Memorandum

To: Cindy Yee, Associate Planner
From: Kelsey Bennett, Project Manager/Senior Environmental Planner
CC: Rod Jeung, Carol Shariat, George Lu, Elliott Schwimmer, Pete Choi
Date: March 13, 2014
Subject: San Ramon Faria Community Preserve IS/MND Changes Summary

In response to public comments received on the Draft IS/MND, the Applicant, Lafferty Communities, has made two changes to the Project: 1) relocation of the proposed primary eastern site access from Deerwood Road to Purdue Road, and 2) relocation of the house of worship site from the northeast corner of Bollinger Canyon Road and Faria Preserve Parkway to Neighborhood V. This memorandum has been drafted in response to the City's request for an examination of the changes to the impacts and mitigation measures presented in the San Ramon Faria Community Preserve Draft IS/MND given the proposed change to the site access and house of worship site location.

Figure 1. Faria Preserve Site Plan

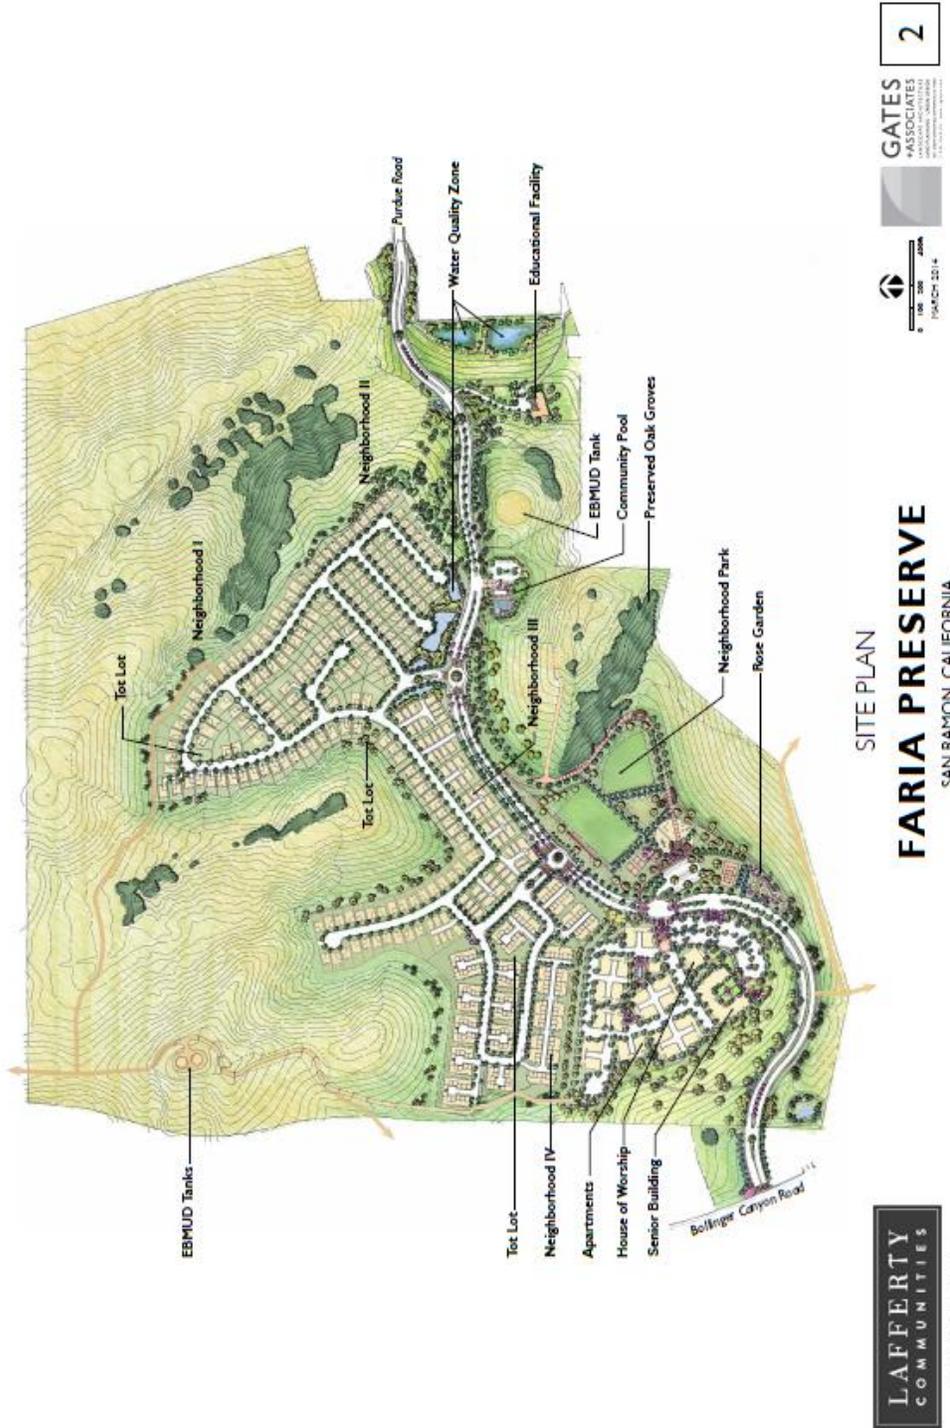
The proposed change in site access would redirect Faria Preserve Parkway from its eastern connection to Deerwood Road to Purdue Road as shown in the revised site plan (see Figure 1: Site Plan). As a result, site ingress and egress to the eastern portion of the Faria Preserve would traverse an industrial area along Purdue Road, rather than the residential neighborhoods along Deerwood Road. The length of roadways on the project site would increase marginally by 270 linear feet, but the overall amount of grading and site disturbance would be essentially the same as described for the proposed project in the IS/MND. In short, the site would still have an overall balance in the amount of earthwork that would be cut and fill on site, and the volume of earthwork would not be expected to change noticeably from the 4,000,000 cubic yards of civil cut and fill and the additional 2,000,000 cubic yards of corrective grading as reported in the December 2013 IS/MND. The construction phases and duration would also remain unchanged.

The proposed relocation of the house of worship site from the northeast corner of Bollinger Canyon Road and Faria Preserve Parkway to the 12.6 acre Neighborhood V parcel would reduce the total Project Land Area from 450 acres to 448.5 acres. As shown in the revised site plan (see Figure 1: Site Plan), the house of worship site would be incorporated within the 12.6 acre Neighborhood V parcel and would result in a reduction of the residential acreage in

Figure 4. Impacts to Jurisdictional Waters with New Purdue Road Site Access

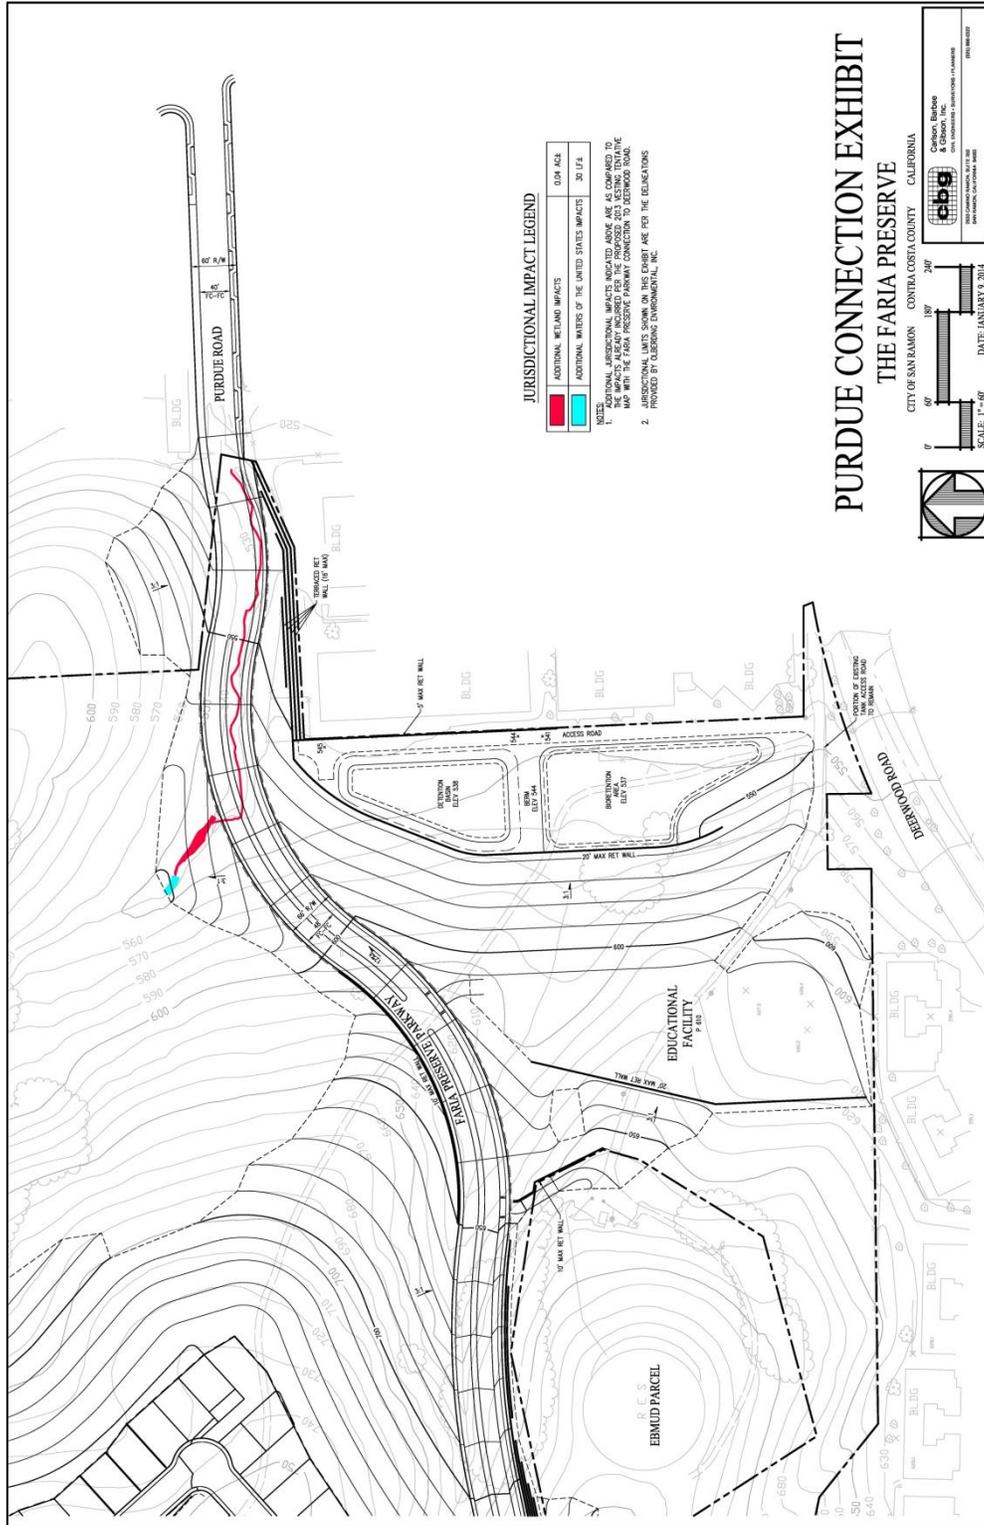
Because the proposed site plan changes would change the site configuration and, thus, areas of cut and fill and the project site, there would be a change in the amount of fill of streams and wetland areas on the project site. Specifically, with the site access change, the extent of jurisdictional drainages affected would increase from 2,090 linear feet to 2,120 linear feet and the fill of wetlands would increase from 0.77 acre to 0.81 acre (see Figure 4). The proposed Mitigation Measure 3.4-4 that requires compliance with the Clean Water Act (CWA) 401 and 404 permitting processes with US Army Corps of Engineers and San Francisco Bay Regional Water Quality Control Board as well as streambed alteration agreement process with California Department of Fish and Wildlife would still apply. The permits from these agencies would be required as conditions of project approval and reduce the effects to less than significant, similar to the finding in the IS/MND. As such, the Applicant would still need to mitigate the fill and/or loss of riparian corridors and wetlands but, now, the mitigation requirements and conditions would reflect the new impact amounts, subject to changes that might occur as a result of the resource agency permitting conditions. Therefore, Mitigation Measure 3.4-4 from the IS/MND would be updated as presented below.

Mitigation Measure 3.4-4: Preserve, Restore, and Create Adjacent Riparian and Wetland Features

Through the CWA Section 404/401 permitting processes with USACE and the San Francisco Bay Regional Water Quality Control Board, as well as the Lake and Streambed Alteration Agreement with CDFW, the Applicant shall mitigate the fill or loss of wetlands and riparian corridors within the construction area. At a minimum, 2,120 linear feet of new ephemeral drainage channel shall be restored or created, 1,115 linear feet of existing drainage channel habitat shall be enhanced, and 0.81 acre of seasonal wetlands shall be created. In addition, 2.18 acres of existing seasonal wetland habitat and 3.60 acres of ephemeral drainage habitat

that currently occur within the project site shall be preserved. In consultation with USACE, the San Francisco Bay Regional Water Quality Control Board, and CDFW, the Applicant shall develop and comply with mitigation measures, permit conditions, and conservation measures identified in the permits, including the creation or restoration of wetlands at an appropriate ratio within the Faria project. Prior to site development permit issuance, the Applicant shall provide to the City all permits issued by the USACE, the San Francisco Bay Regional Water Quality Control Board, and CDFW as evidence of the agencies' acceptance of the mitigation plans by the permitting agencies. The permits may modify and would supersede the mitigation linear feet and acreages identified above. Securing the permits and compliance with permit conditions and measures stipulated by the permits shall be conditions of the City's project approval.
